GE Hitachi Nuclear Energy

Subject: **Response to Portion of NRC Request for Additional Information Letter No. 168 Related to the ESBWR Design Certification – Licensing Topical Report NEDO-33337 ESBWR Initial Core Transient Analysis – RAI Numbers 15.2-16, 15.2-18, 15.2-24, 15.2-28 through 15.2-30 and 15.2-38**

**Response to Portion of NRC Request for
Additional Information Letter No. 168
Related to ESBWR Design Certification Application**

**Licensing Topical Report NEDO-33337
ESBWR Initial Core Transient Analysis**

Figure 15.2-28-1 – FWT Response Comparison

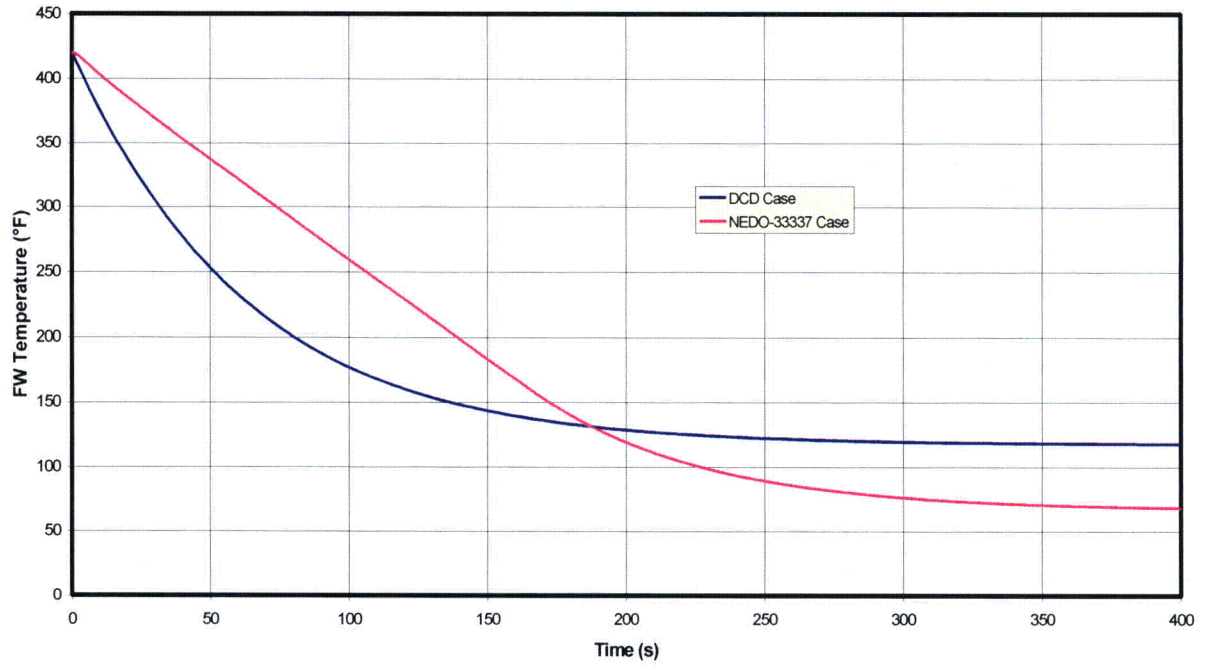
SCRRI/SRI power increase Section 2.3.2.4.3 of NEDO-33337 states SCRRI/SRI will activate to reduce the power to 60% in the Turbine Trip with Turbine Bypass analysis. In Figure 15.2-6a of DCD Tier 2, SCRRI/SRI does reduce power to 60%, where power then appears to stabilize. In Figure 2.3-6a of NEDO-33337, power is shown to reduce to 60% but then increase to approximately 75%. This is additionally shown in the results of the Generator Load Rejection with Turbine Bypass analysis in Figure 2.3-4a, where power approaches 80%. Explain this power increase and describe if it continues to rise after the 400 seconds.

In the Generator Load Rejection and Turbine Trip with Turbine Bypass (LR/TTWBP) event evaluated in LTR NEDO-33337, the assumptions for feedwater (FW) temperature response following a LR/TTWBP were adjusted in TRACG to more accurately model the expected response based on the ESBWR balance of plant design (See DCD Tier 2 Table 10.1-1 and Figure 10.1-2). The FW temperature reduction following the event was adjusted to simulate the effect of the No. 4 heater (open FW heater). An unintended result of the change to the TRACG simulation was to lower the resulting, post event, steady state FW temperature to a temperature lower than is expected, ~20 °C (68°F). This lower steady state FW temperature is responsible for the increase in power observed at the end of the LR/TTWBP.

The FW temperature comparison for the TTWBP case in DCD Tier 2, Figure 15.2-6 and NEDO-33337, Figure 2.3-6 is shown in Figure 15.2-28-1. Note that the FW temperature in the NEDO-33337 case is very close to being steady at 400 seconds; however, the core power may increase a few more percent as the reactor comes to steady state. The FW temperature following a LR/TTWBP is expected to be closer to 49°C (120°F) (as shown in the rated heat balance DCD Tier 2, Figure 10.1-2) or higher, which would result in a steady state power level closer to, or lower than the DCD LR/TTWBP evaluation. The reduced steady state FW temperature produces conservative Δ CPR/ICPR results. Note that the limiting Δ CPR/ICPR comes from channel number 2420 (See NEDO-33337 Figure 2.6-6g). The minimum CPR for channel 2420 is approximately 1.40 at about 36 seconds, which is well below the value at 400 seconds (1.49); therefore, if the power increases slightly and CPR decreases slightly as the event comes to steady state, the channel number 2420 CPR will remain above the minimum during the transient. Because the results in NEDO-33337 are acceptable, no changes are made to the LTR.
